Results of Review of Geant4 Electromagnetic Code

John Apostolakis/CERN, Andrea Dotti/SLAC, Krzysztof Genser/FNAL, Soon Yung Jun/FNAL, Boyana Norris/Univ. of Oregon and ANL

HEP-ASCR Meeting Fermilab, January 30th, 2015

G4VProcess class diagram

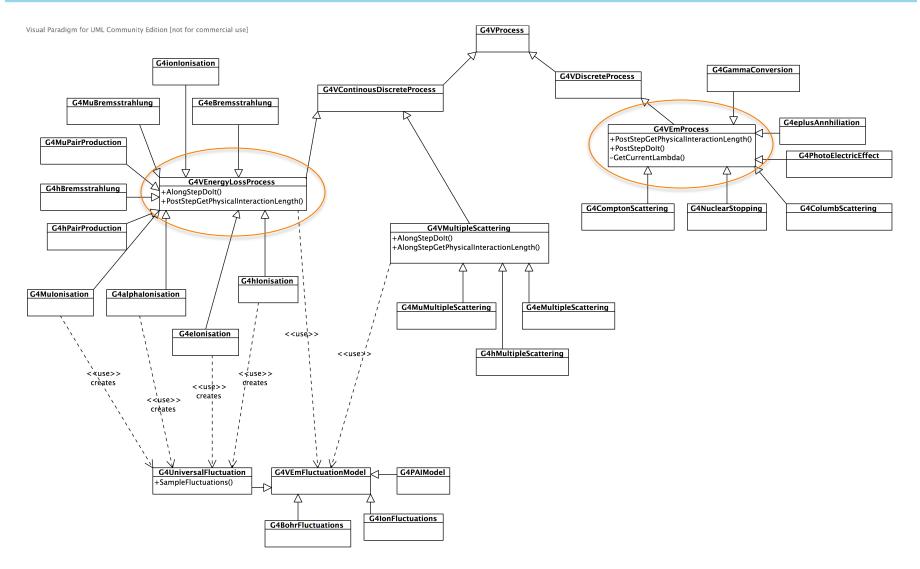
Make code more intuitive

- Most electron processes inherit from G4VContinuousDiscreteProcess and yet behave as G4VDiscreteProcess
 - i.e. inherit from G4VEnergyLossProcess vs. G4VEmProcess
 - Could one move electron daughter classes from one to the other?
 - Two quite similar classes can they be consolidated?
 - A very non obvious code makes sure that "continuous" AlongStepDolt functions are not called
- The class structure should be simplified or at least the code made more obvious
- Complicated side effects should be avoided or at least well documented
